2 H@NC - 40 Eagle Crest Court, Lillington, NC 27546

# PLAN 1 The Clayton - LH

10-15-24 - Redlines -JJ

THE CLAYTON - LH  
Cover Sheet 'Low Country'

**SLAB FOUNDATION PLAN 'LOW COUNTRY'**  
SCALE: 1/8"=1'-0" ON 11x17, 1/4"=1'-0" ON 22x34

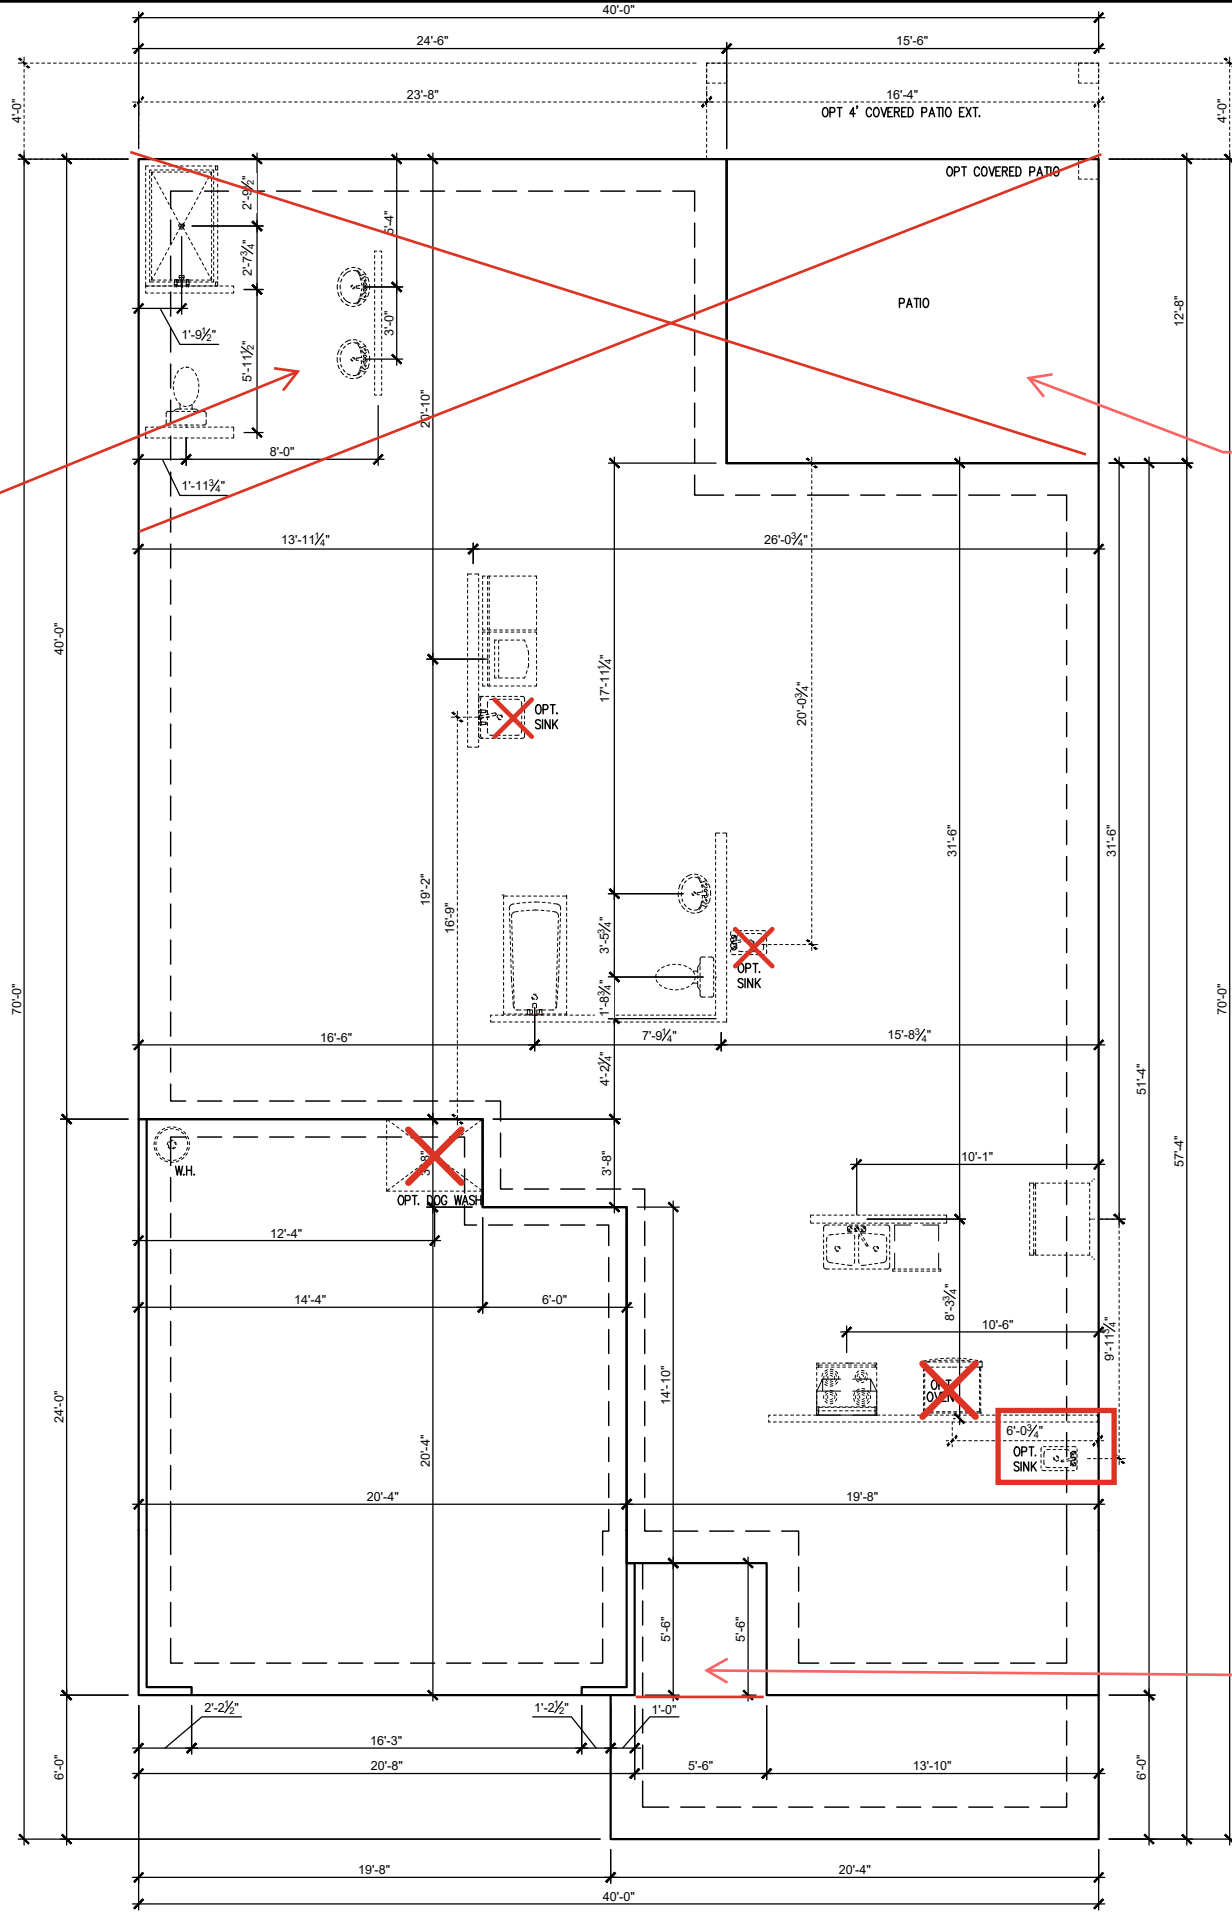
Sheet 1.1.1a for porch with Family room fireplace

Sheet 1.1.1a for smart door delivery

**FIRST FLOOR PLAN 'LOW COUNTRY'**  
SCALE: 1/8"=1'-0" ON 11x17, 1/4"=1'-0" ON 22x34

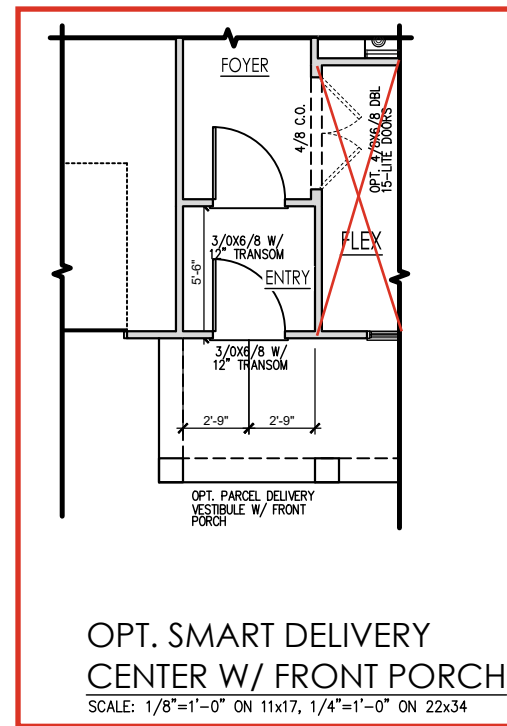
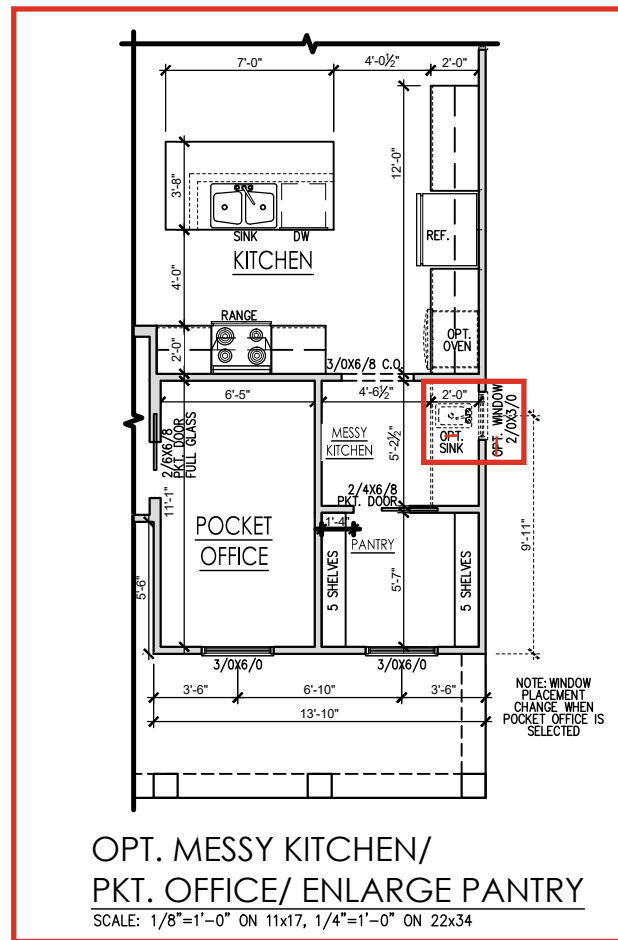
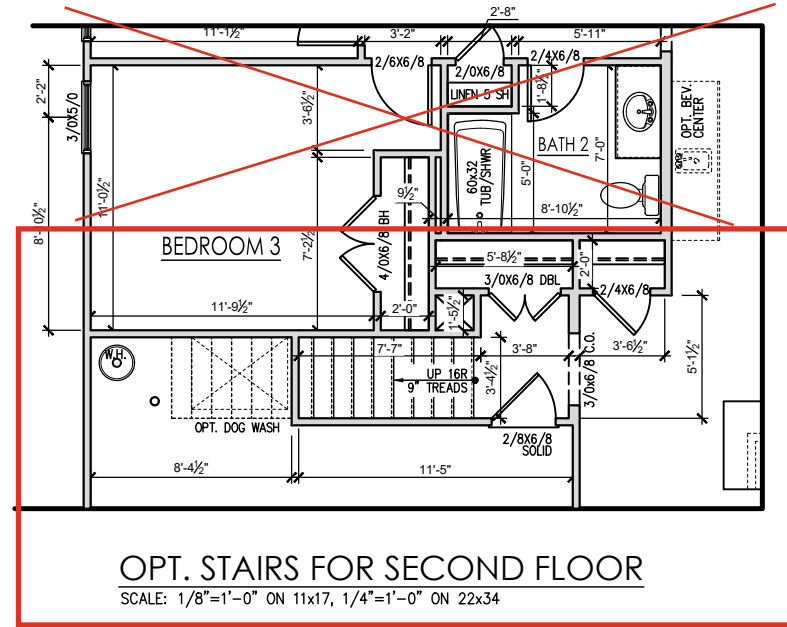
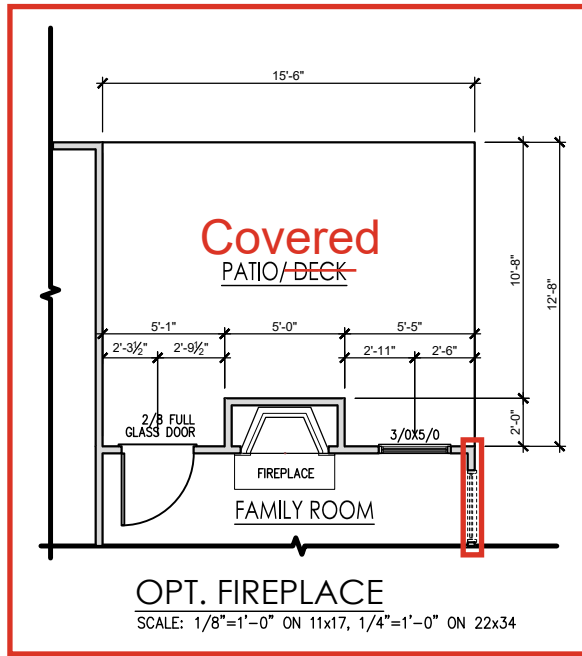
2.1.2a for owner's suite with large walk in closet and bath with tub and shower w/ seat

Sheet 2.1.1a for stairs to 2nd floor

2.1.1a for family room fireplace

2.1.1a for Kitchen, Messy Kitchen, Pantry, Pocket Office and Smart Door Delivery

**OPT. OWNER'S SUITE W/ LARGE WALK-IN CLOSET**  
 SCALE: 1/8"=1'-0" ON 11x17, 1/4"=1'-0" ON 22x34

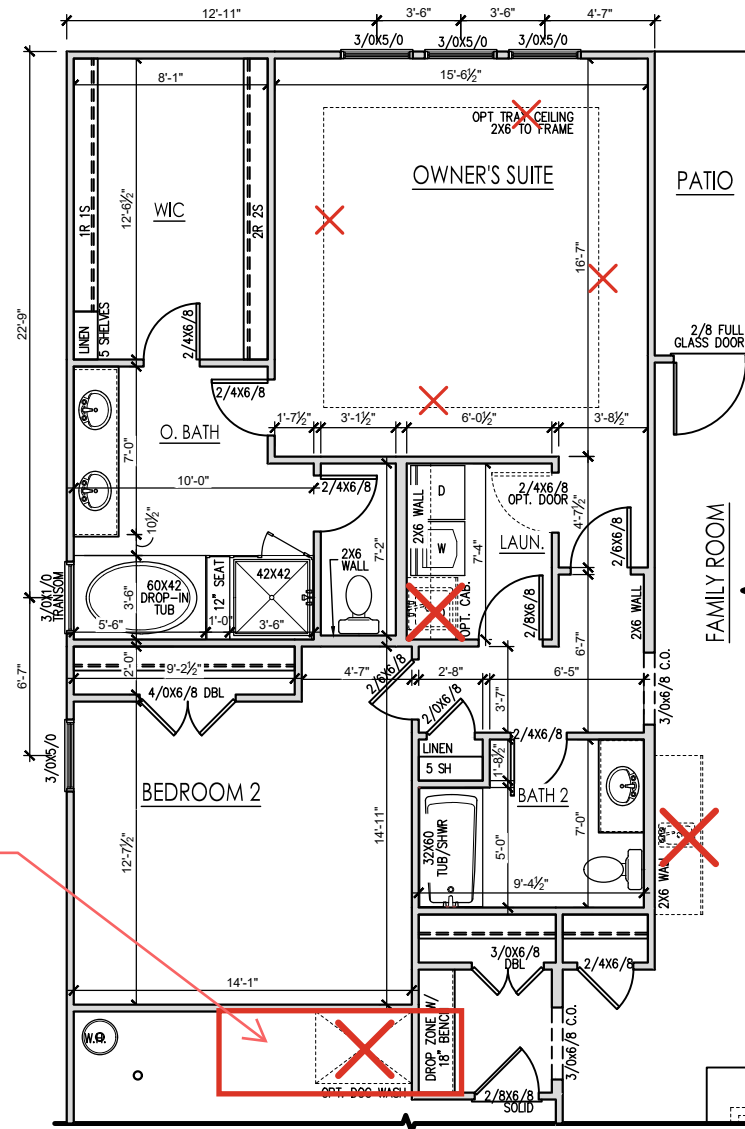
stairs - 2.1.1a

**RIGHT SIDE ELEVATION 'LOW COUNTRY' (SLAB)**  
SCALE: 1/8"=1'-0" ON 11x17, 1/4"=1'-0" ON 22x34

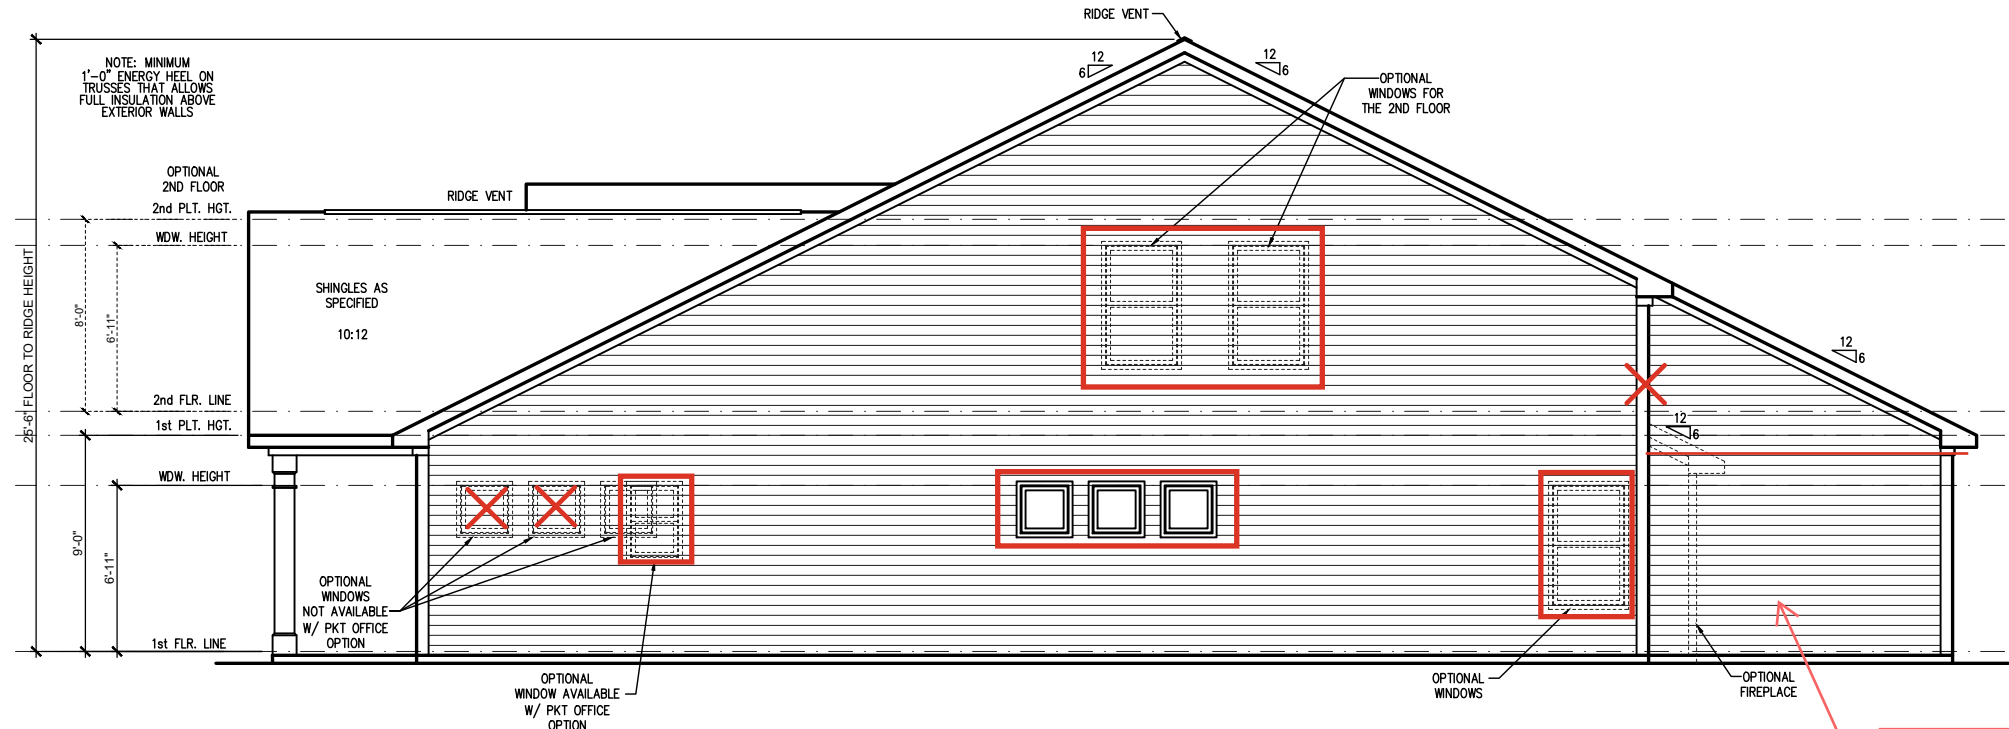
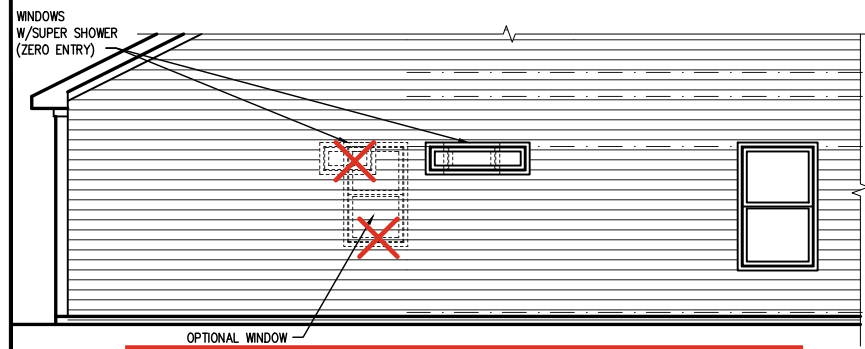
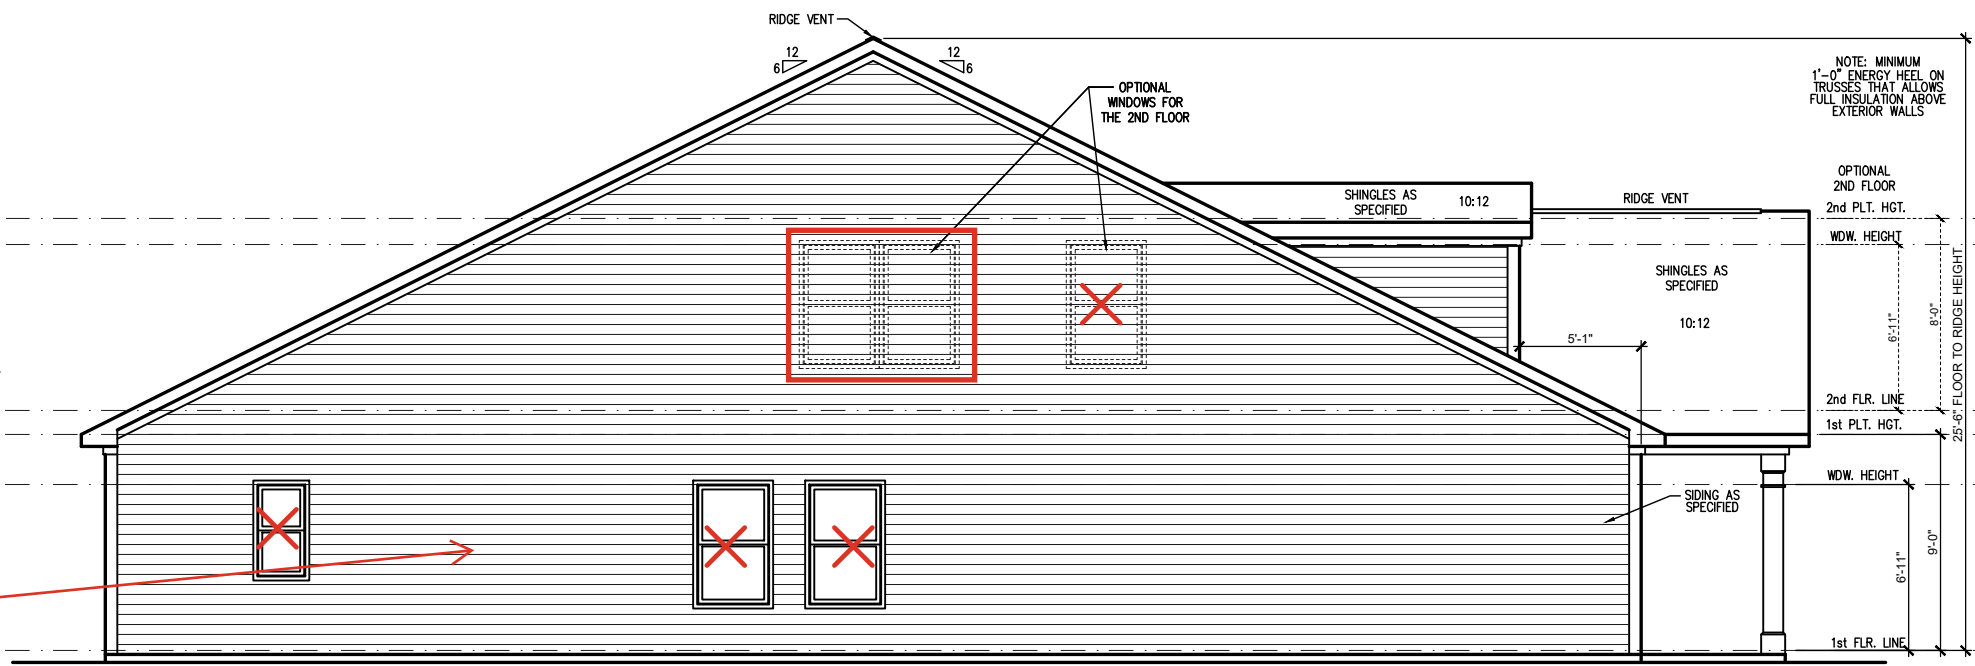
2.4a - covered porch

**LOW COUNTRY ROOF PLAN**  
 SCALE: 1/4" = 1'-0" ON 22x34, 1/8" = 1'-0" ON 11x17

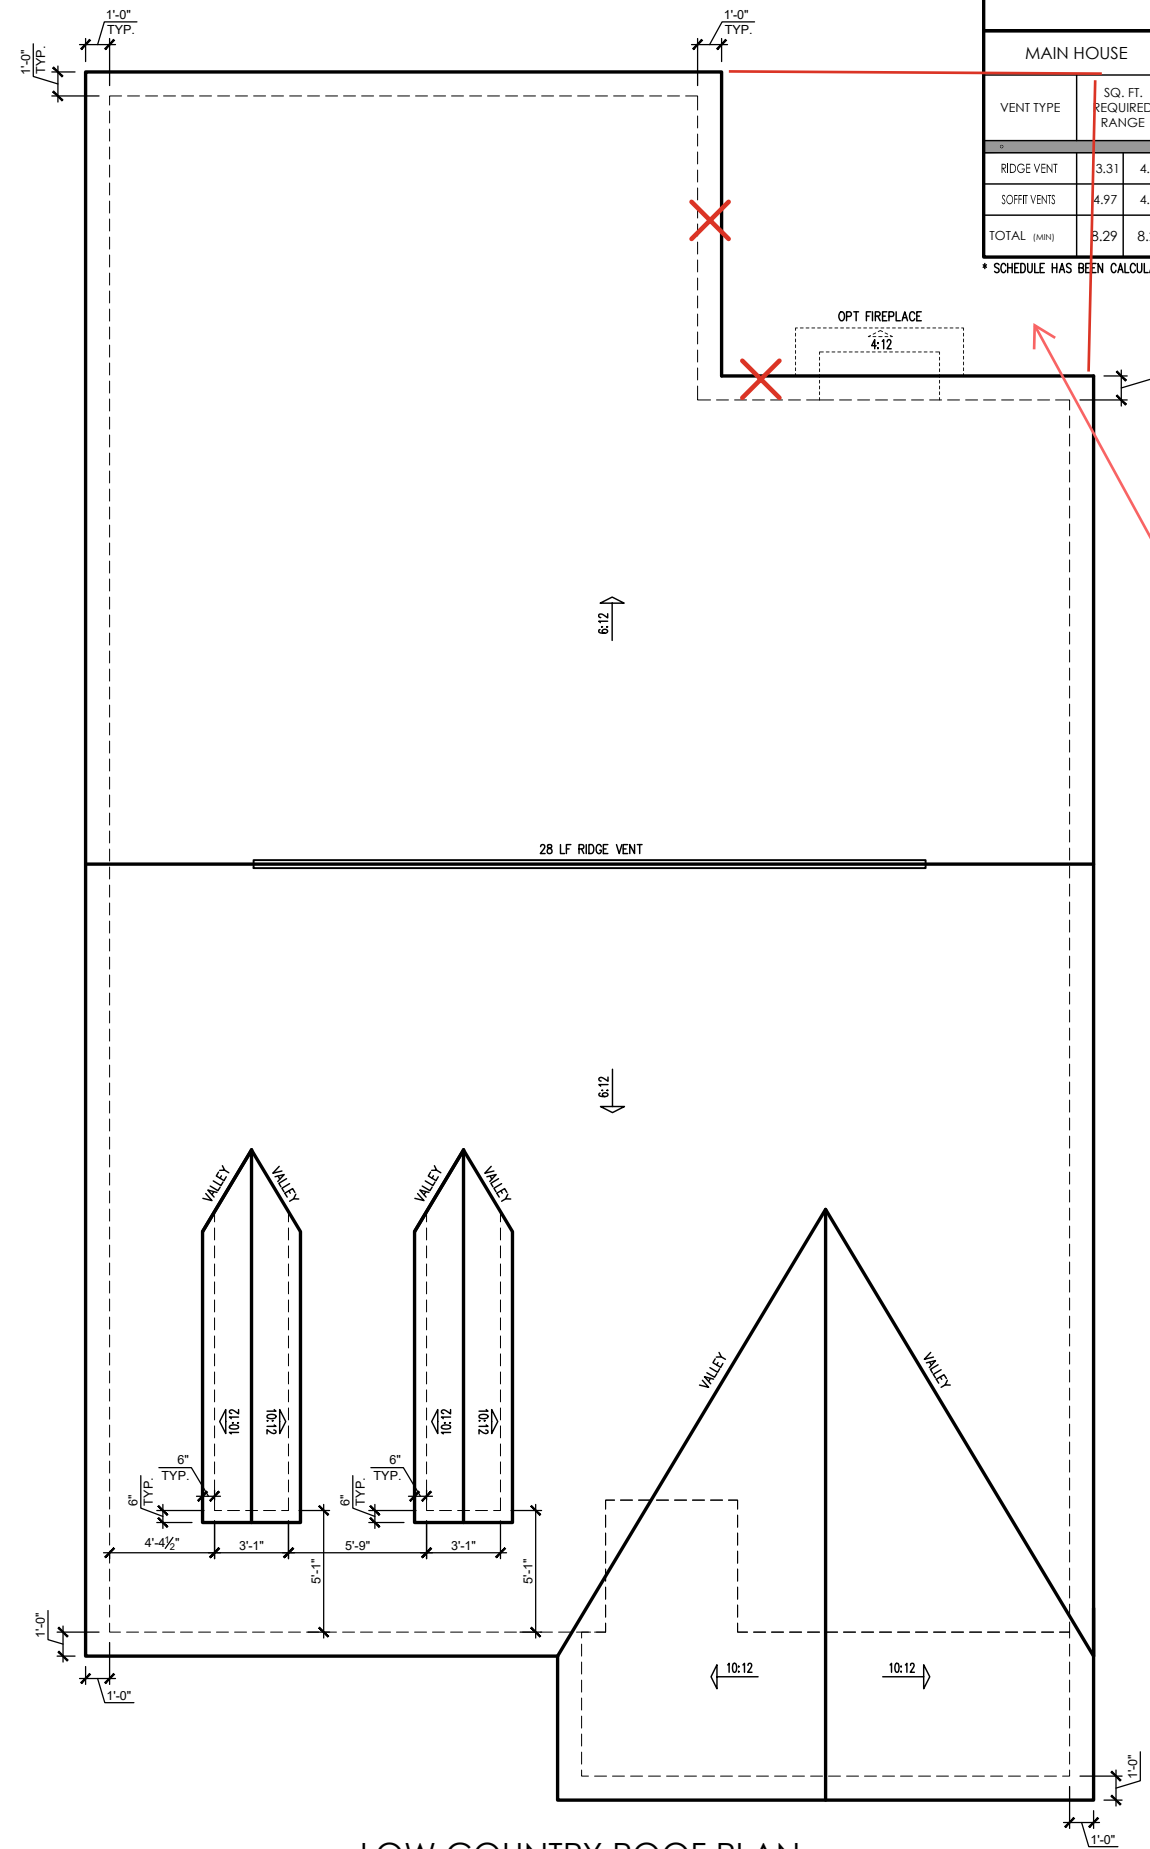
2.4a - covered porch
